Difference „old“ 2.0EVN and 3.0EVN (266-735):

ALT:

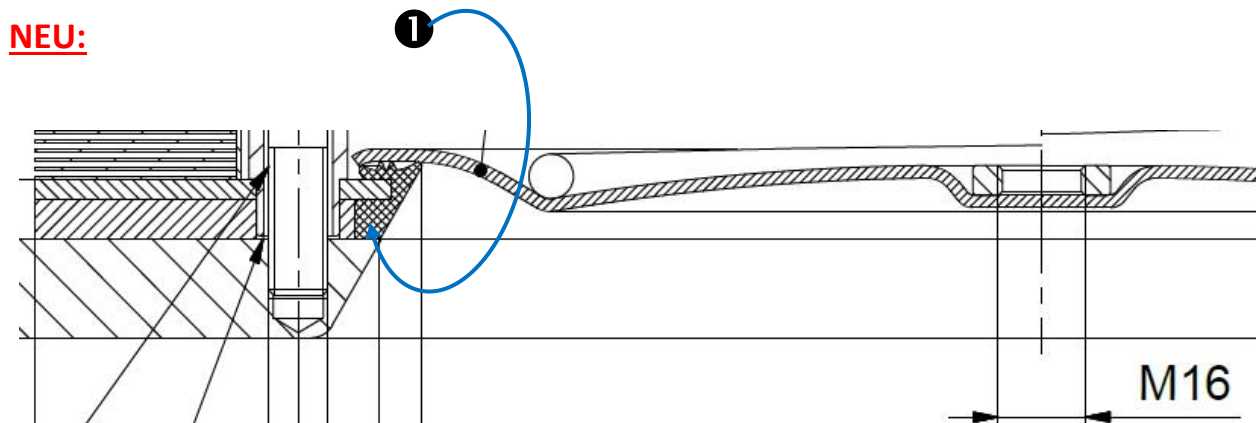
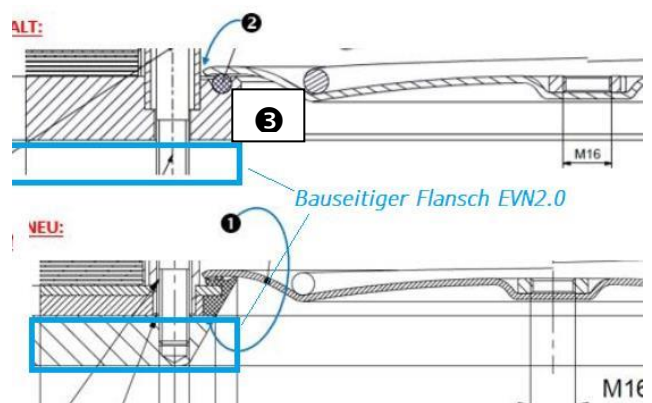
Anstatt dem O-Ring kommt jetzt auch beim „normalen EVN“ die neue Dichtung, sie ist lamellenartig und hat auch bessere Funktion bei Staubpartikel zwischen Ventilplatte und Dichtung. Es gibt sie in EPDM und Silikon.

- Max. Prozesstemperatur 120°C bei EPDM Dichtung
- Max. Prozesstemperatur 180°C bei SILIKON Dichtung
 - Umgebungstemperatur -20°C bis 80°C

Die neue Dichtung reicht bis zum Ventilflansch, der Kunde benötigt daher keine zusätzliche Dichtung bei der Befestigung an seiner Anlage (Silo, Filter, ...) ❶

Die neue Dichtung umschließt den Ventilsitz, das Staubmedium/das Produkt kommt daher nur mehr mit dem Ventilteller in Berührung, nicht mehr mit dem Ventilsitz ❷

Für Kunden, die EVN2.0 bereits verwenden und ggf. auf EVN3.0 wechseln, ist der Flanschinnendurchmesser größer als beim EVN2.0. Das heißt, wenn die kundenseitige Konstruktion nicht auf den InnenØ vom 3.0 angepasst wird, hat der Kunde hier einen Rücksprung und ein potenzielles Hygieneproblem. Daher bitte die bestehenden Kunden entsprechend informieren. ❸

NEW:

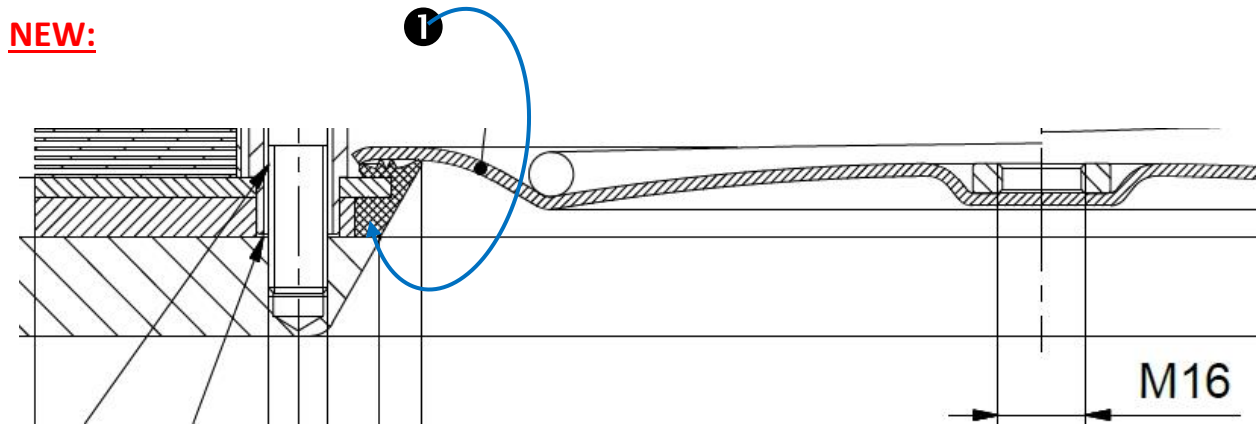
Instead of the O-ring, the "normal EVN" now has the new seal, it is lamellar and also has a better function with dust particles between the valve plate and the seal. They are available in EPDM and silicone.

- Max. process temperature 120°C with EPDM seal
- Max. process temperature 180°C with SILIKON seal
 - atmosphere temperature -20°C to 80°C

The new seal extends to the valve flange, so the customer does not need an additional seal when attaching it to his system (silo, filter, ...) ❶

The new seal encloses the valve seat, so the dust medium/the product only comes in to contact with the valve plate and no longer with the valve seat ❷

For customers, who are already using EVN2.0 and may be switching to EVN3.0, the inner diameter of the flange is larger than that of the EVN2.0!

This means that if the customer's construction is not adapted to the inner diameter of 3.0, the customer has a setback and a potential hygiene problem. Therefore, please inform existing customers ❸
